ADDENDUM #4

Will County Health Department
BID PACKAGE #3 – MEP/Finishes/Carpentry/Glazing
December 6, 2018

RFI LOG
Will County Health Department
Bid Package #3 Addendum #4 12/6/18

FIRST FLOOR STRUCTURED CABLING - AREA 'A'

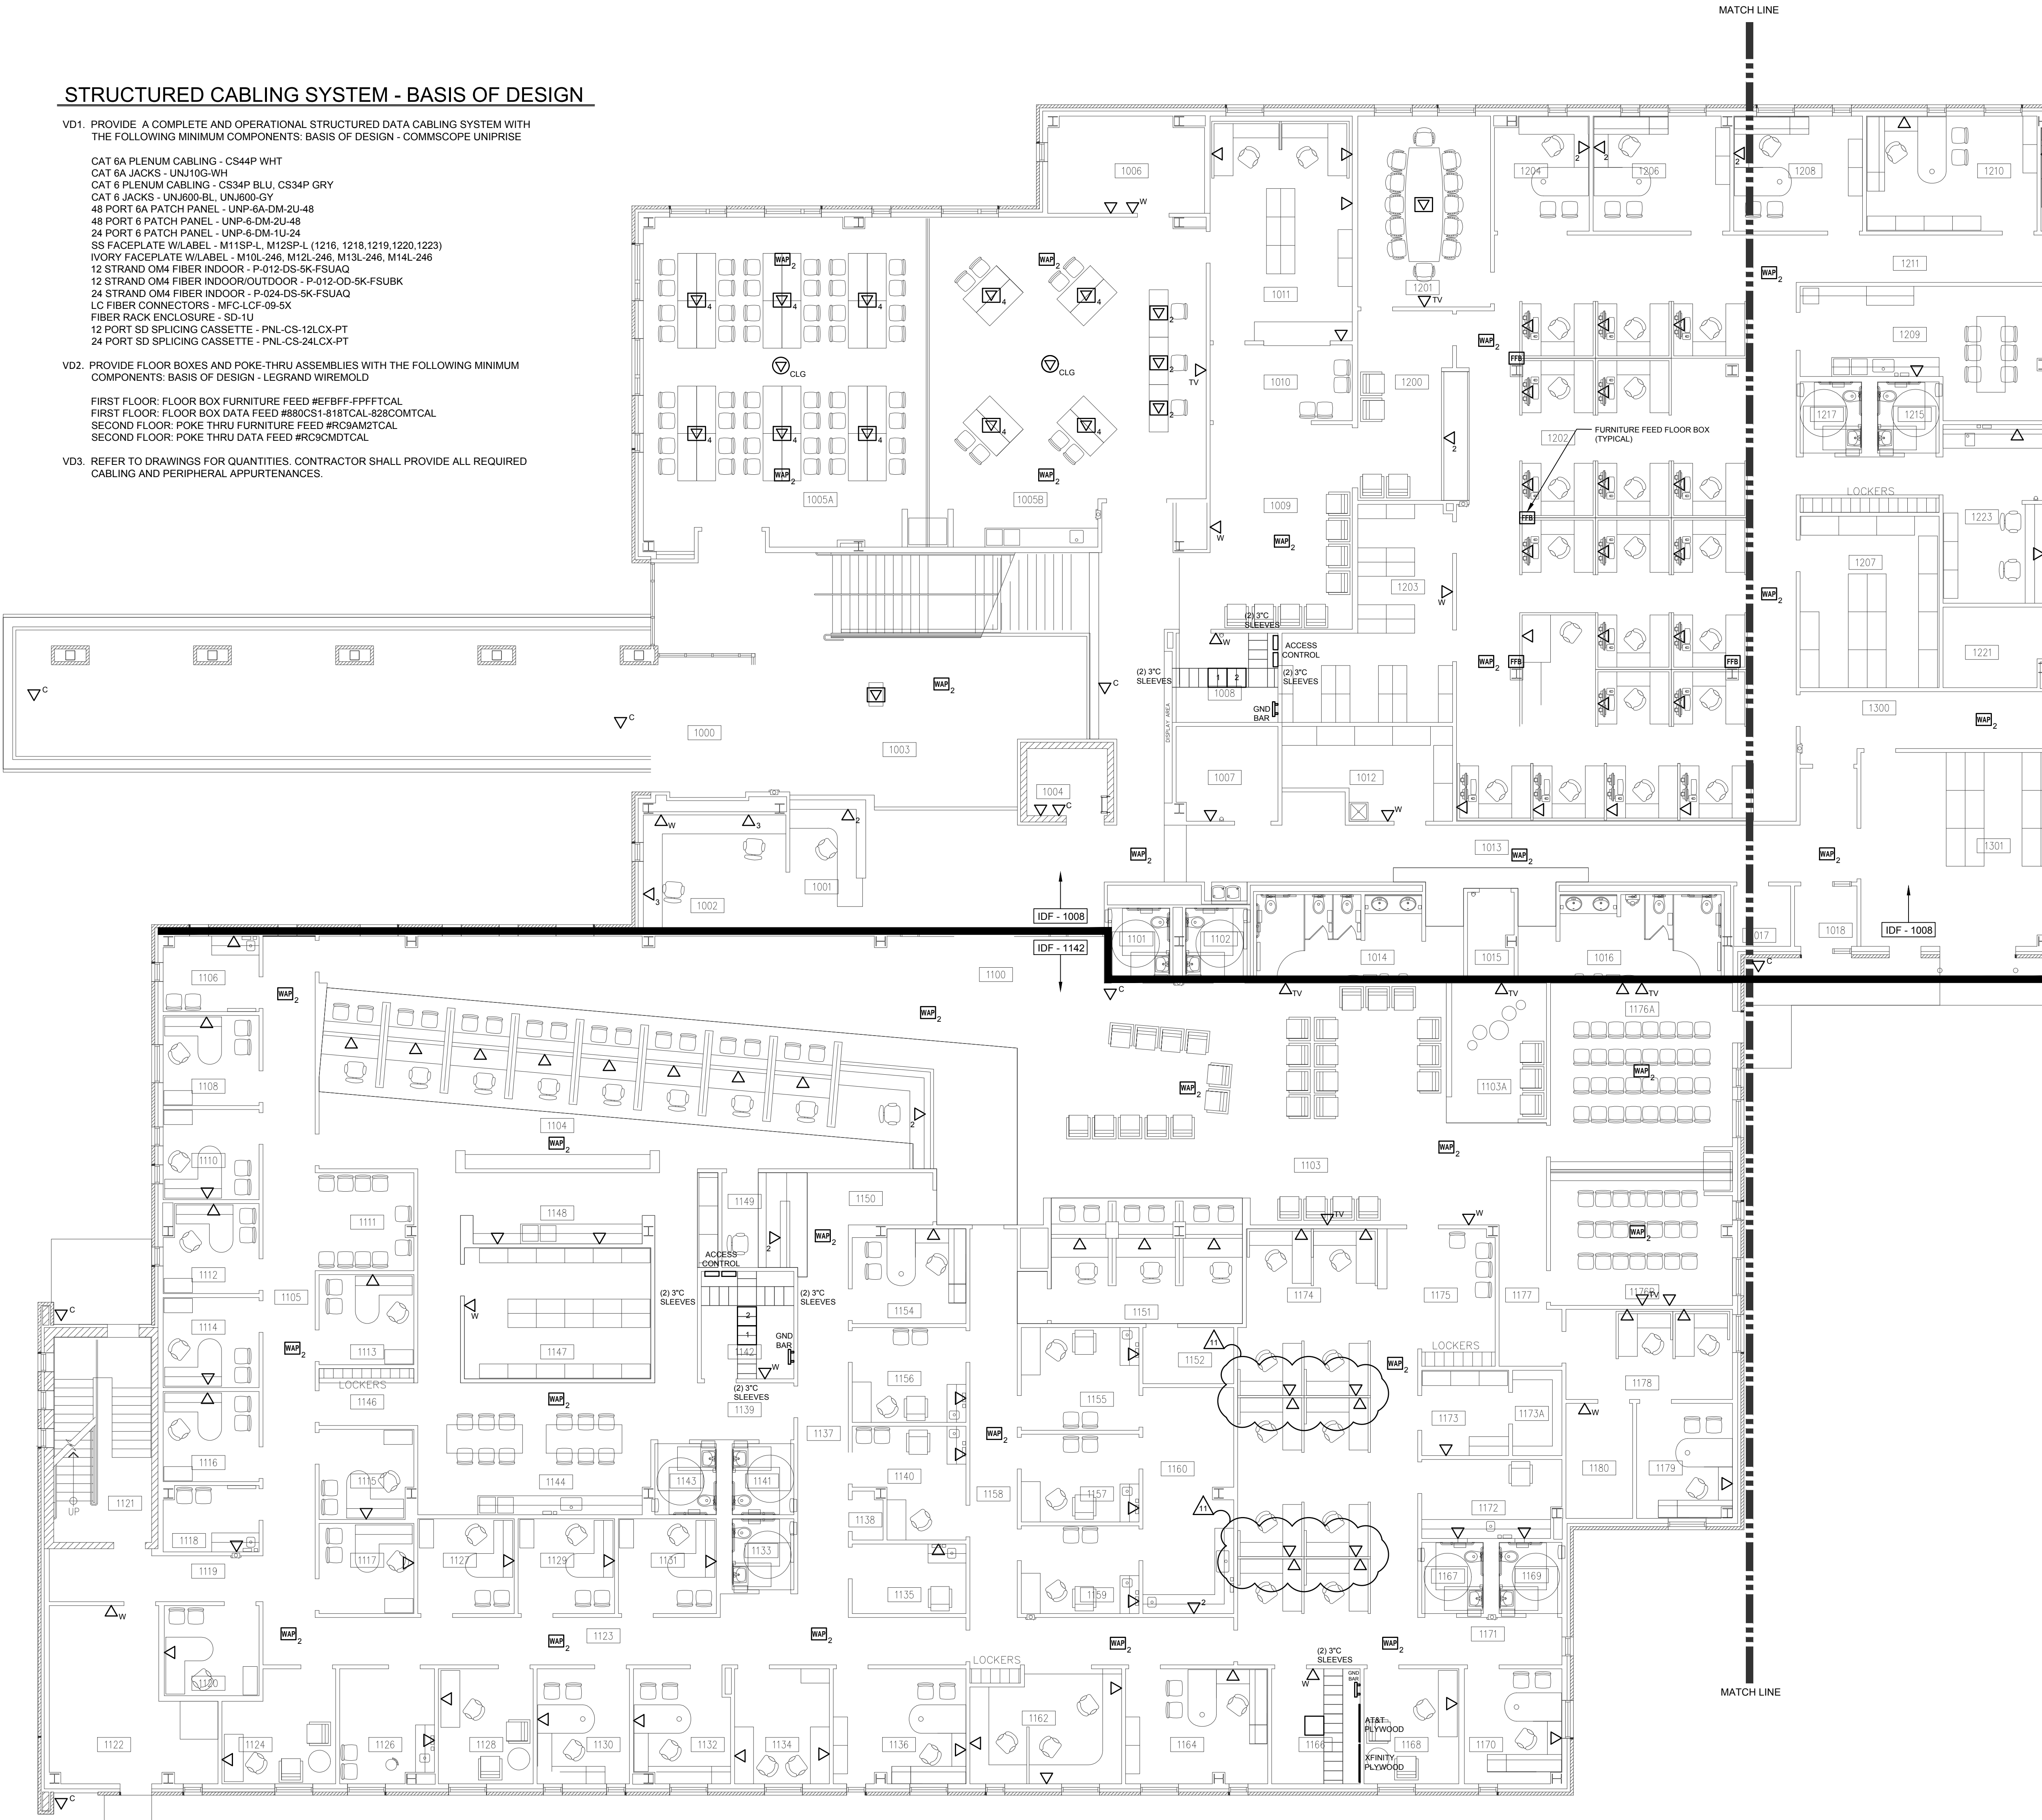
2.21 DRAWING T311 - FIRST FLOOR STRUCTURED CABLING - AREA A

FIRST FLOOR SPECIAL SYSTEMS - AREA 'A'

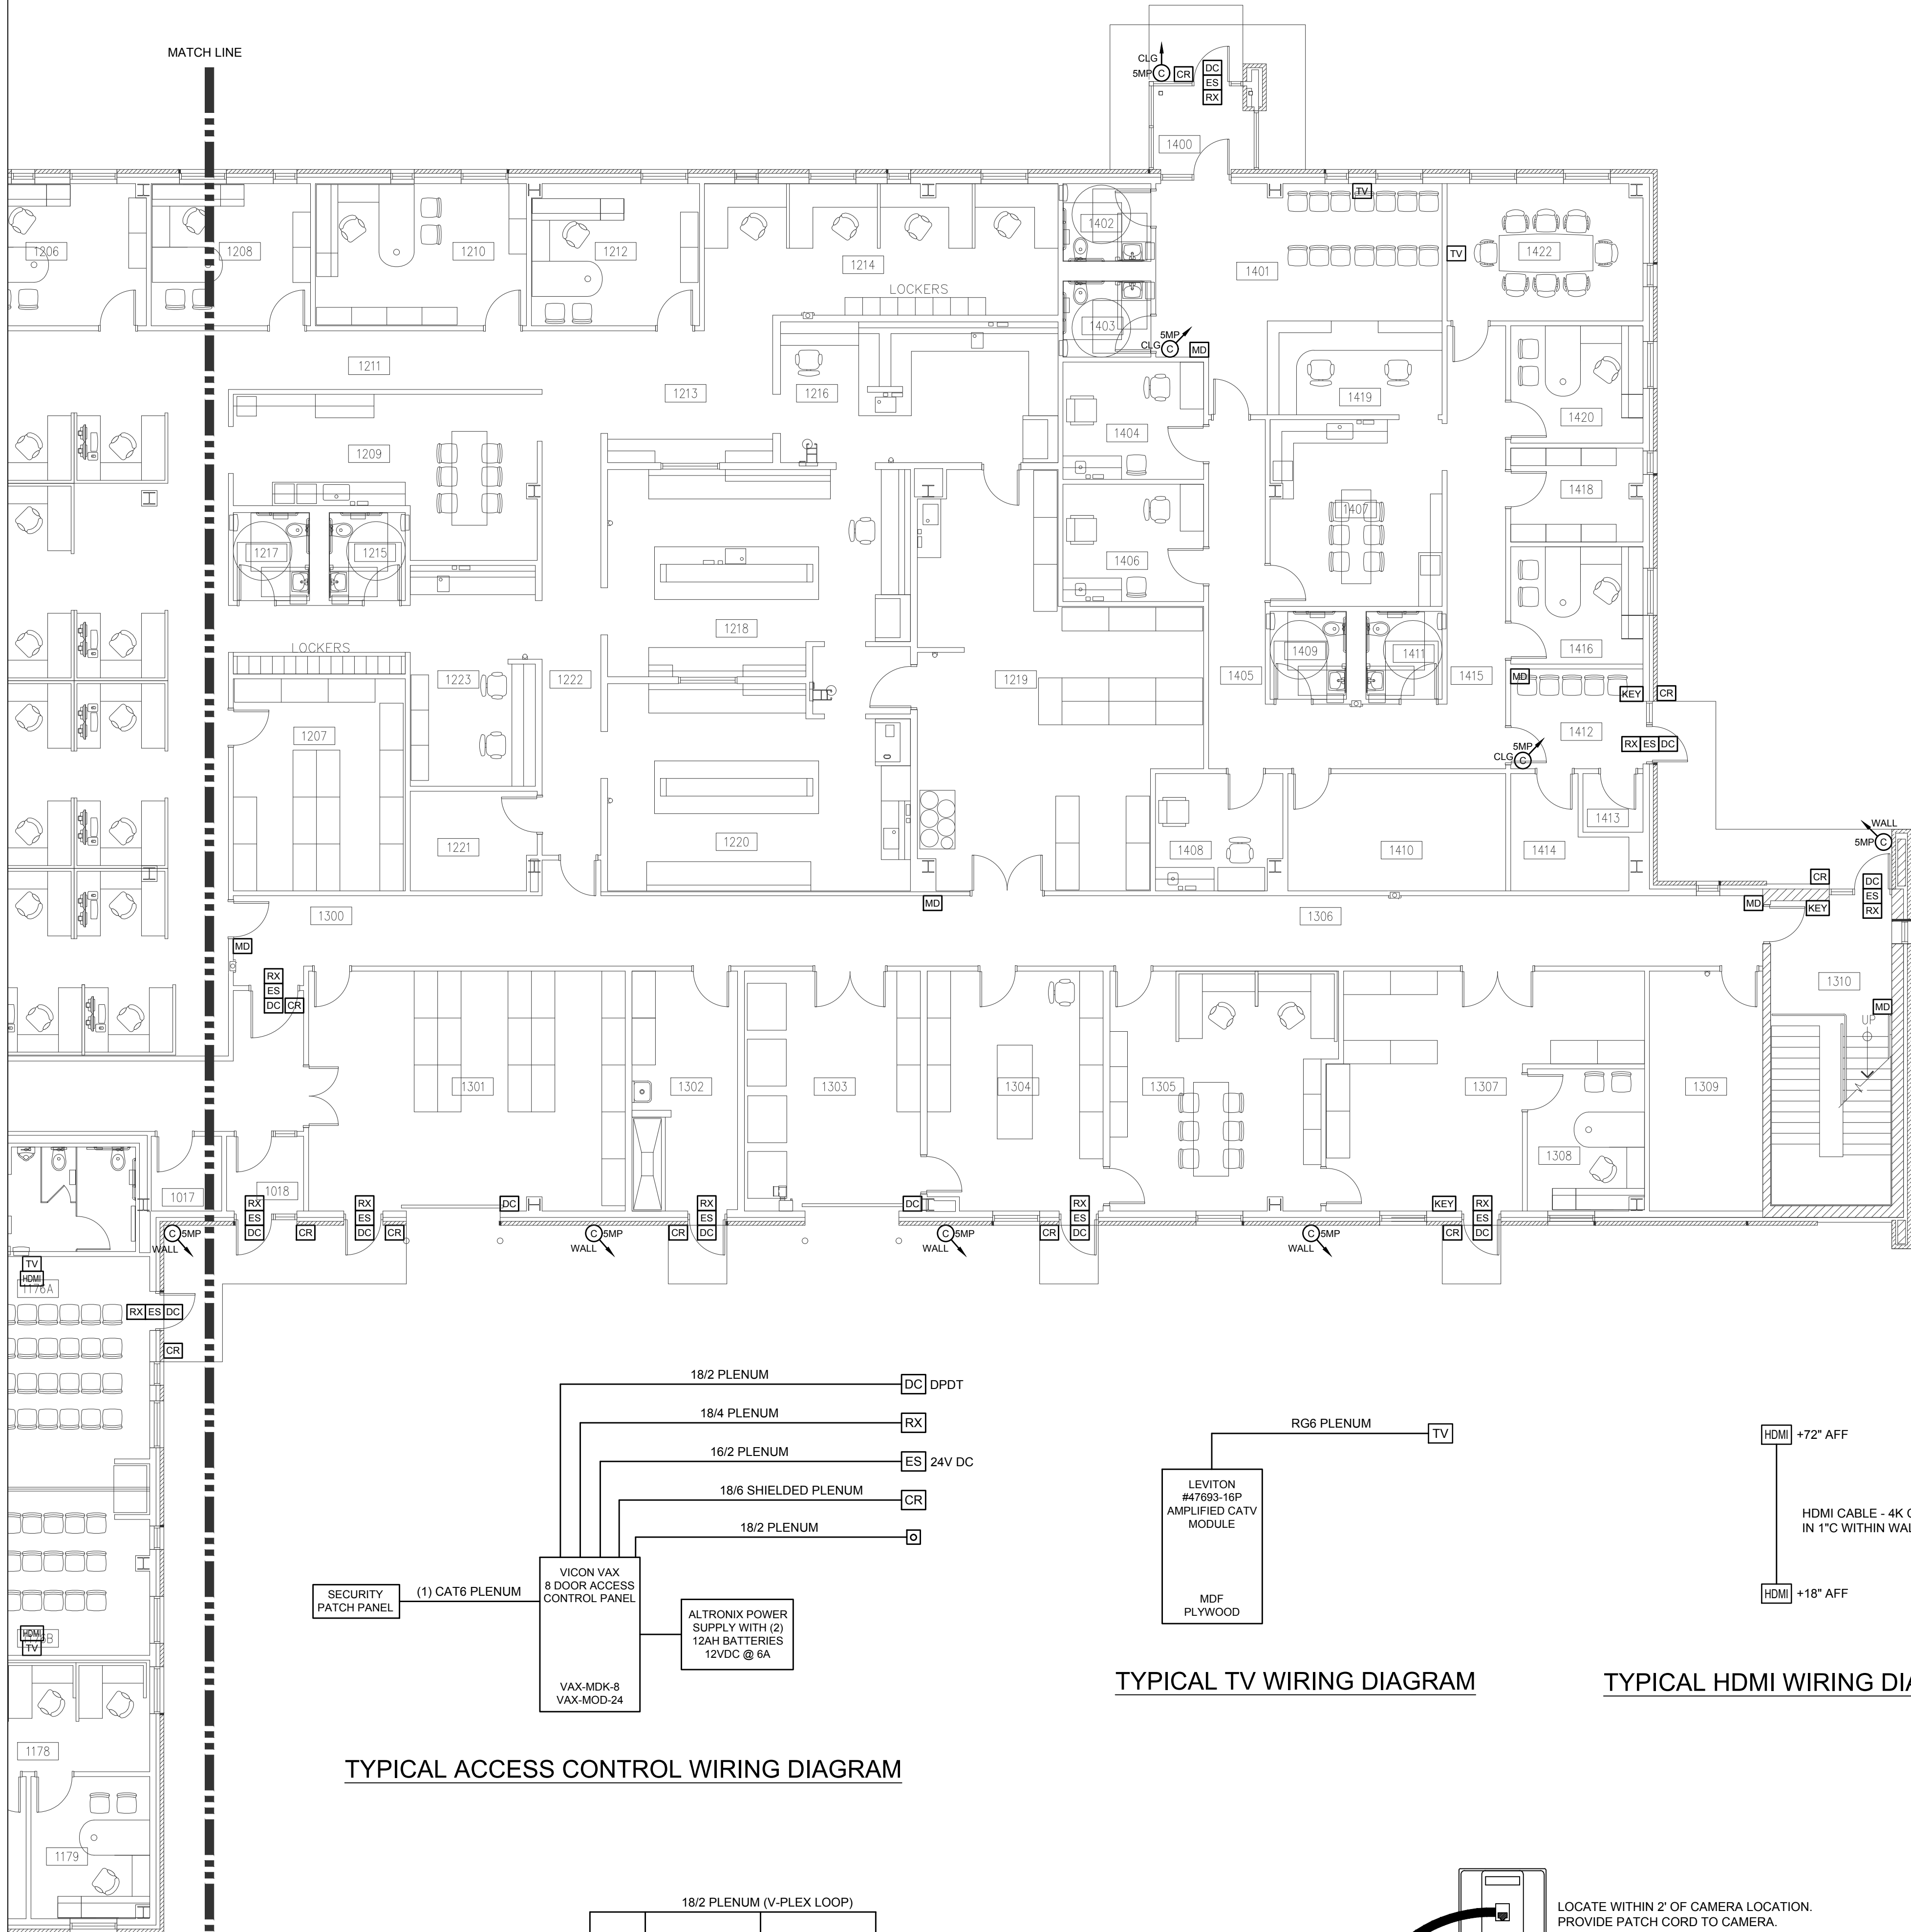
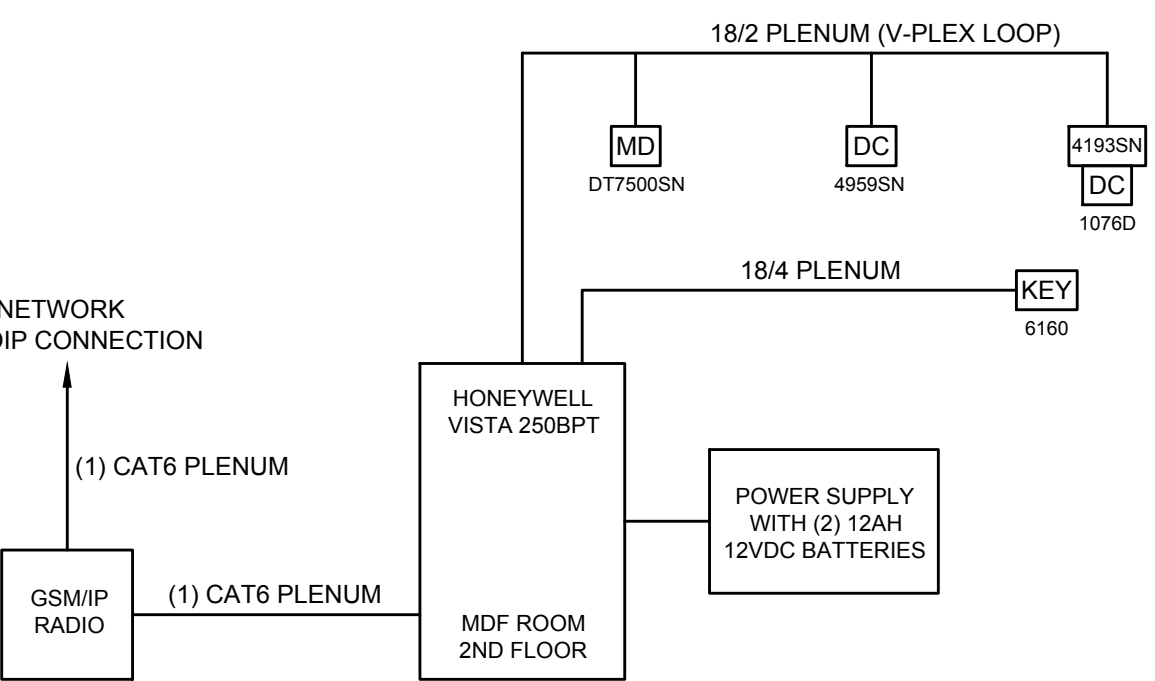
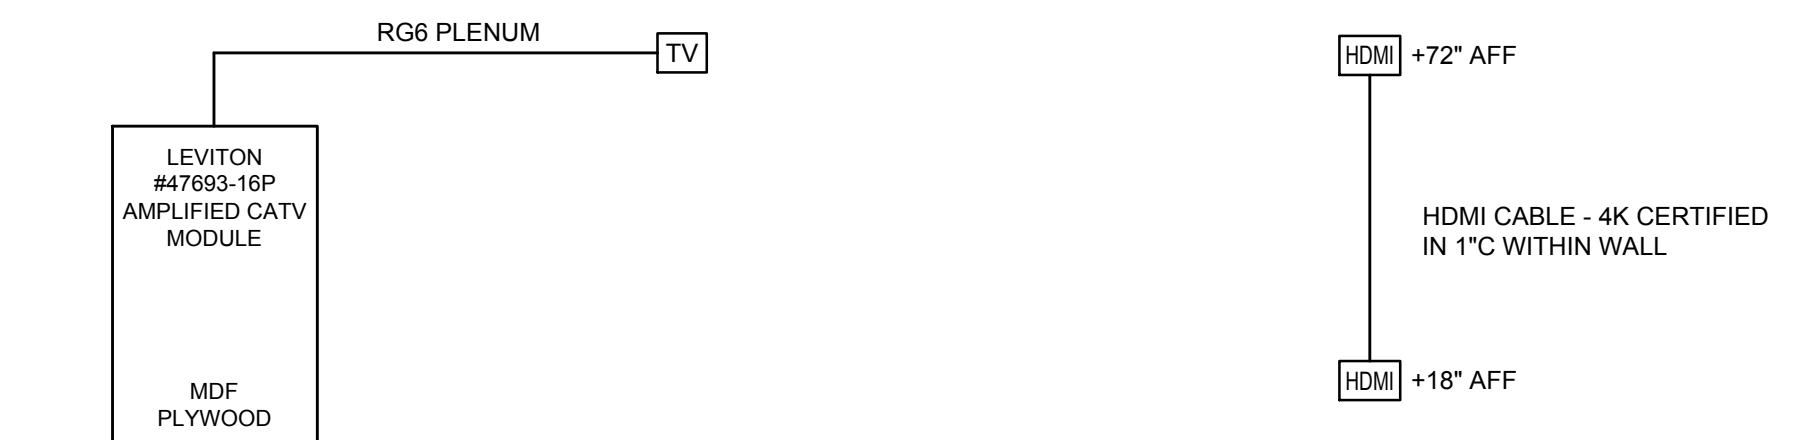
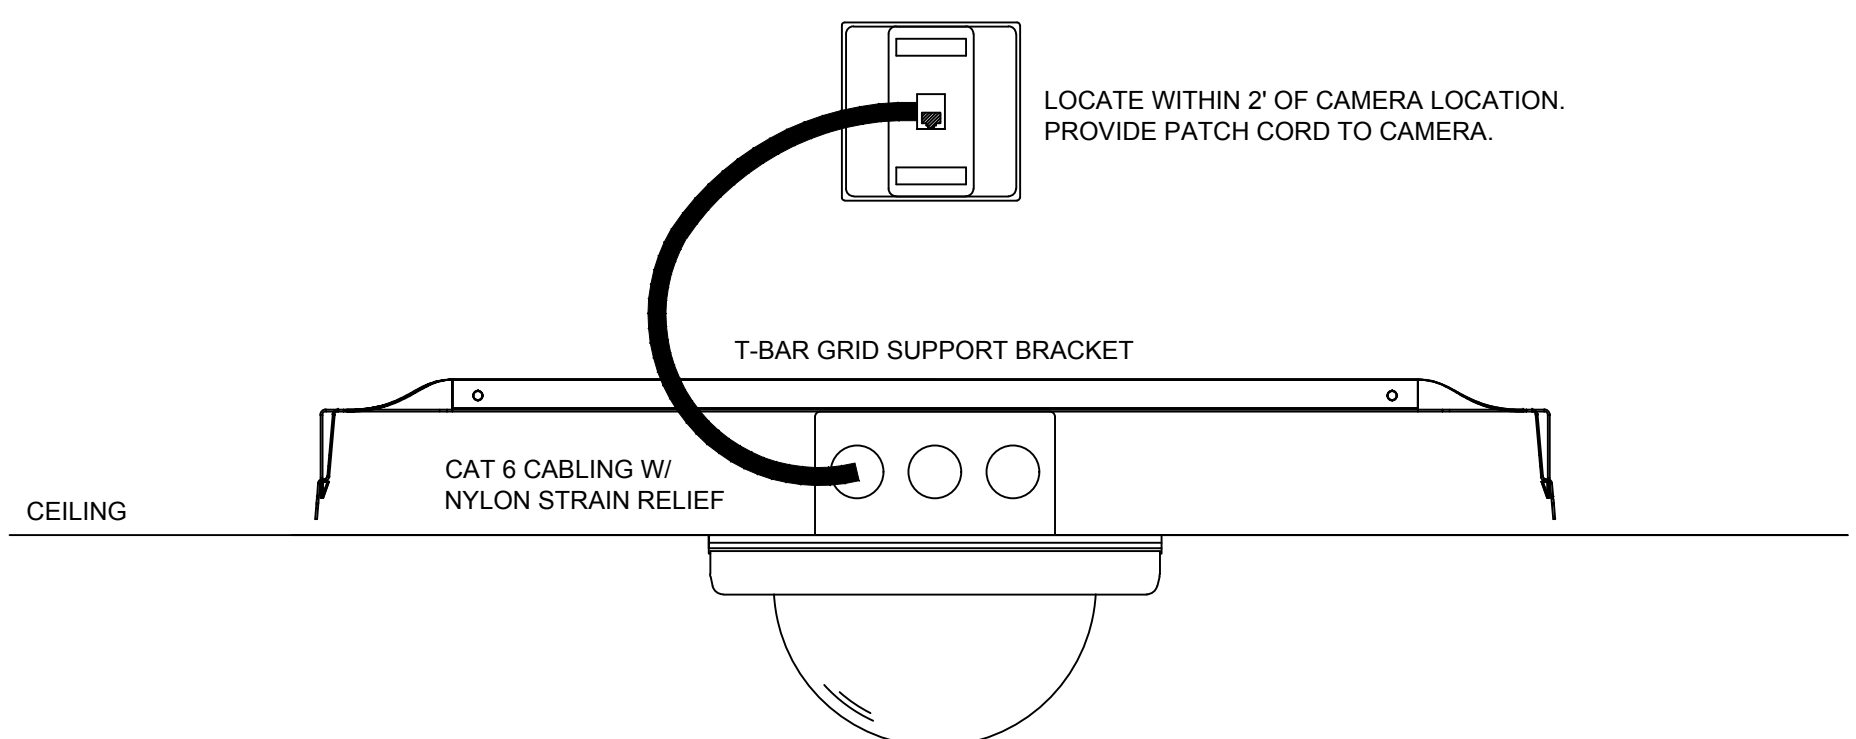
2.22 DRAWING T411 - FIRST FLOOR SPECIAL SYSTEMS - AREA A
